**CITY OF SOUTH PASADENA
DESIGN REVIEW BOARD
MEETING AGENDA**

- 1. **Project No. 2268-NID/DRX – Notice of Intent to Demolish a 1,081 square-foot single-family home and 2 car-garage and Design Review for a new 2,500 square-foot single-family home and attached 2 car-garage at 95 Short Way Street.**

- 2. **Project No. 2317 –DRX - Design Review for a 1,488 square foot, single-story addition to an existing 1,770 square foot, single-story house and construction of a new two-car detached garage located at 2065 Marengo Avenue.**

Figure 5: Proposed Site Plan

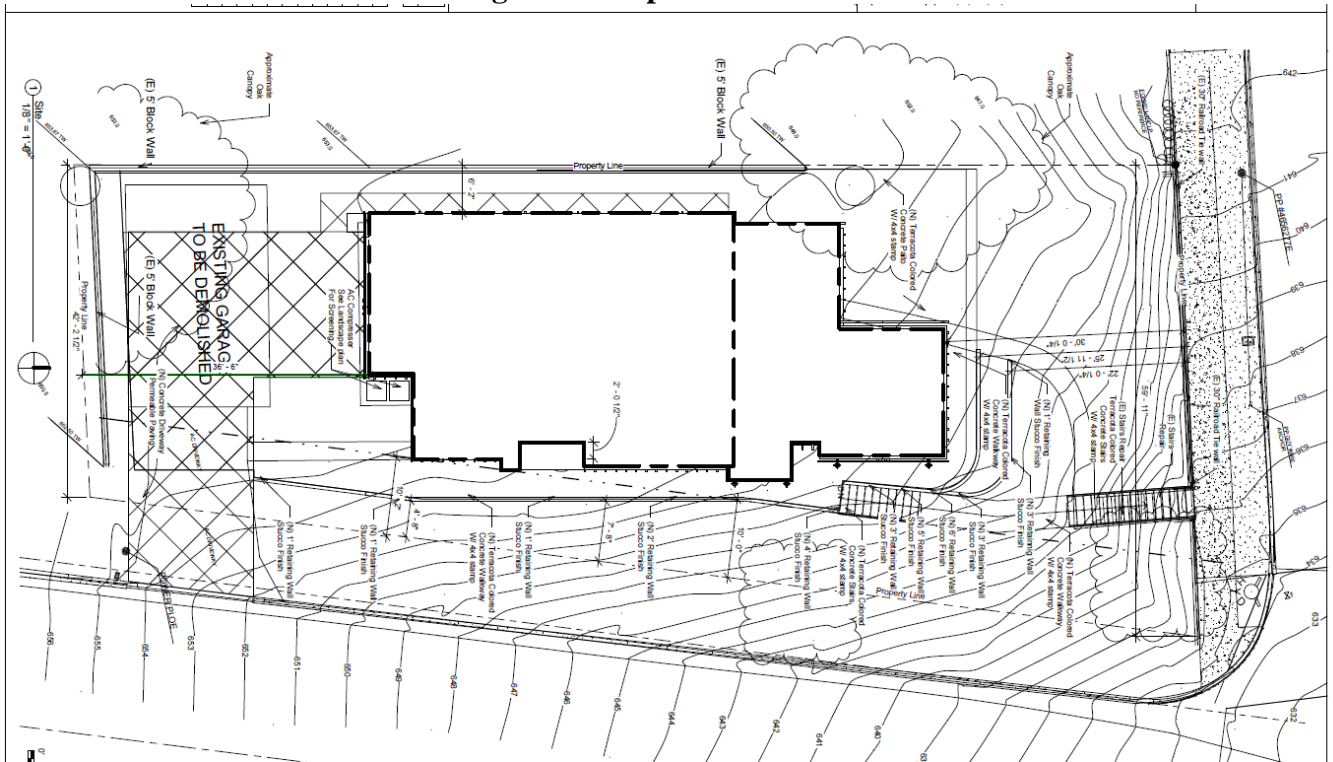
A condition is also included to require the applicant to submit revise plans showing screening for the proposed a/c condenser with a permanent screen such as a wall or fence because the proposed vegetation screening is not a permanent screen.

- b. Show screening of the A/C condenser with a wall or other permanent structure as approved by the Director Planning and Community Development. The method of screening shall be architecturally compatible with the colors, materials, and architectural style of other development on the site. Landscaping cannot be used as screening

Figure 3: Existing and Proposed Site Plans

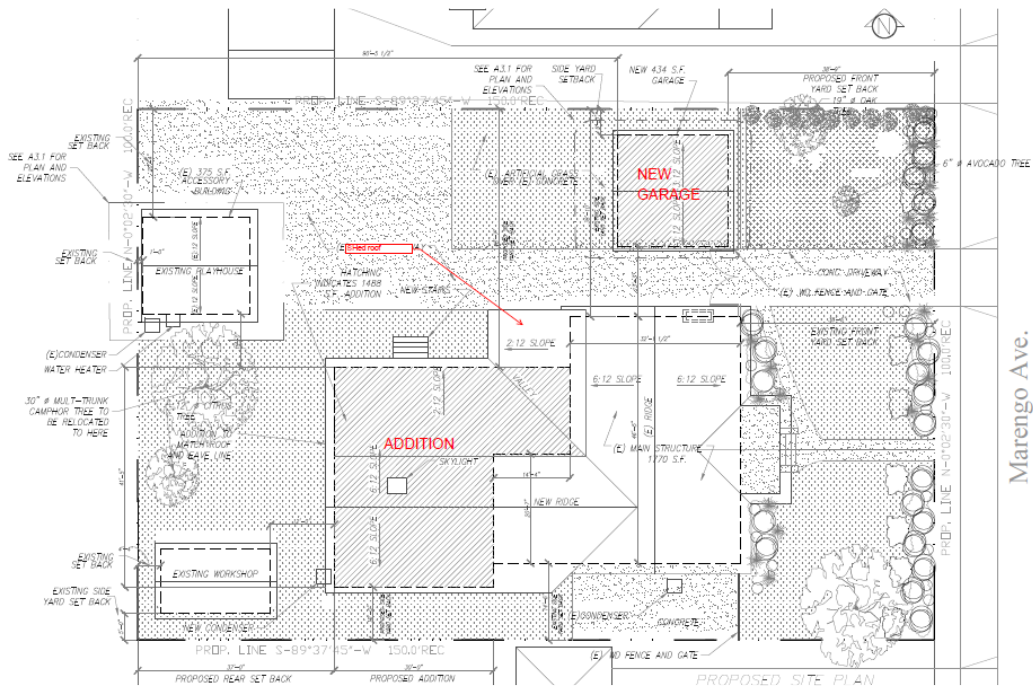
Camphor Tree	<p>A 30-inch multi-trunk Camphor tree is shown on the Existing Site Plan and in the site photographs, but not shown on the Proposed Site Plan.</p>	<p>The Applicant would like to relocate the Camphor tree on the project site therefore, a Tree Removal Permit is required.</p>

Figure 6: Existing and Proposed West Elevations (Rear)

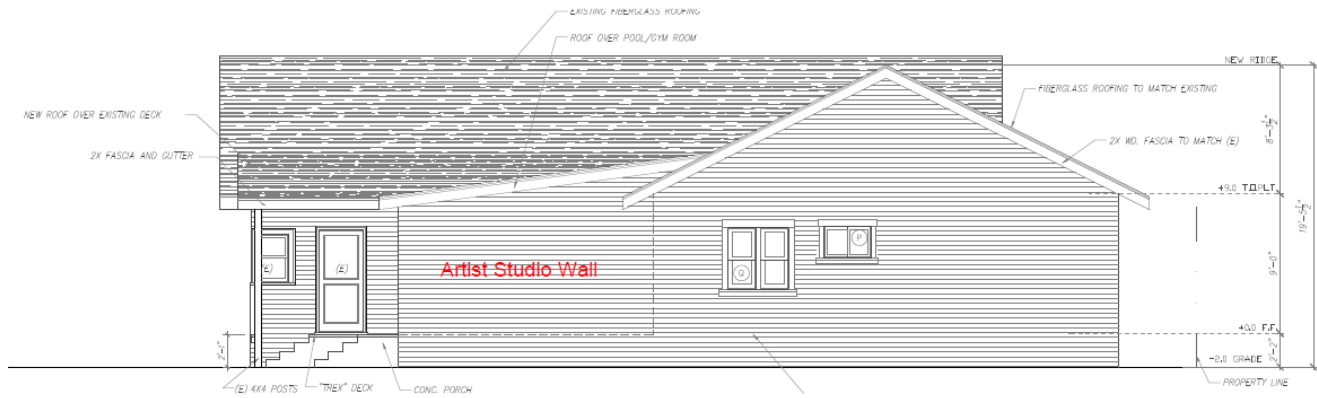
- Redesign of the street-facing garage gable.
The Design Review Board Subcommittee's decision on the location and orientation of the garage could eliminate the impact on the street frontage. As a result, this condition may be modified or removed at the discretion of the Design Review Board Subcommittee.
- Addition of articulation and visual interest to the home's west elevation.

A condition of approval was added requiring that a minimum of three grouped double-hung windows be added to the west wall of the Artist Studio.

Figure 10: Garage Floor Plan and Path of Travel

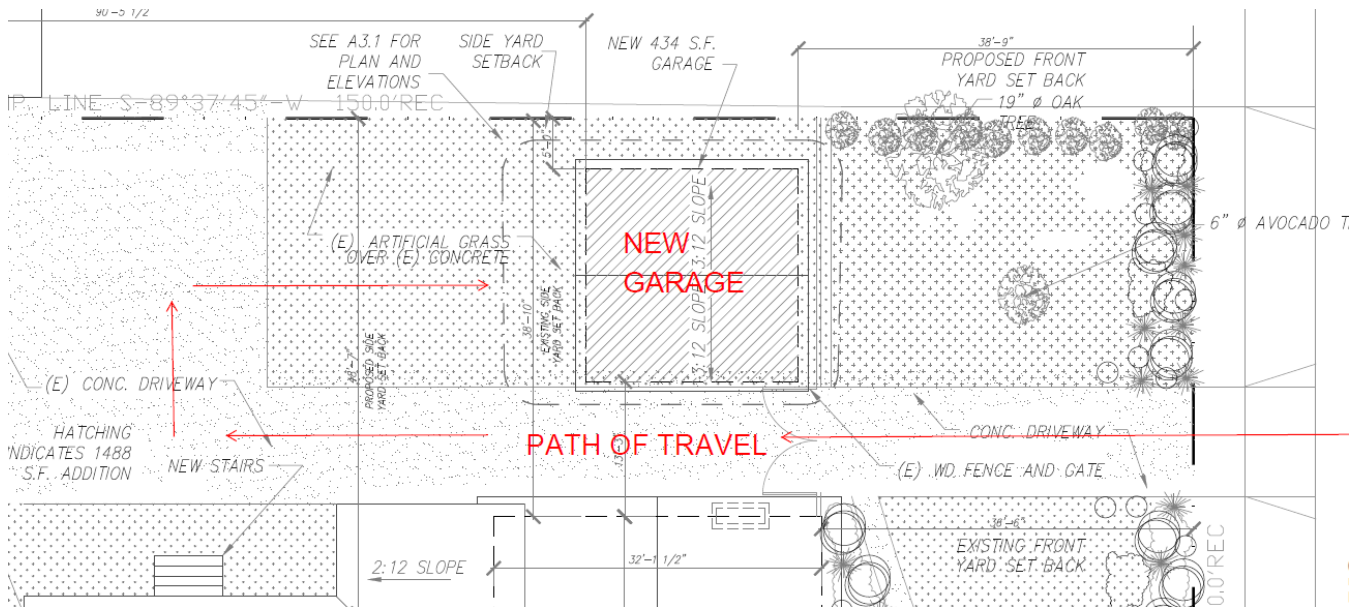
- Access to the garage is awkward as shown in **Figure 10**. As discussed in **Table 2**, the location of the garage is even with the existing residence; this will negatively impact the streetscape by creating an almost continuous wall across the 100-foot wide lot frontage.
- The proposed garage location may not be possible due to potential impacts on soils stability resulting from infilling the swimming pool.

To provide the Subcommittee with the information required to address these specific concerns, one of the proposed conditions of approval requires the Applicant to provide a soils report prepared by a licensed engineer. The report shall define the area of the lot impacted by filling the pool and describe the ability of soils in and surrounding that area to support a structure prior to the first meeting of the subcommittee.
